Technical Service Information

TOYOTA A340 MULTIPLE SHIFT PROBLEMS

Figure 1

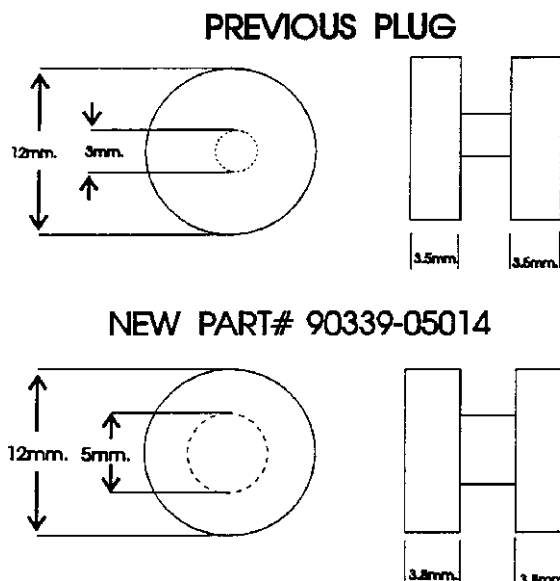
COMPLAINT: Multiple shift problems including misses 2nd gear, misses 3rd gear, no downshift, no overdrive, or cannot cancel overdrive.

CAUSE: Broken or cracked end plugs. Problem may not be visible unless valves are removed

CORRECTION: Install updated (stronger) end plugs, also replace retainers designed to accommodate the new end plugs (see figures 1 & 2).
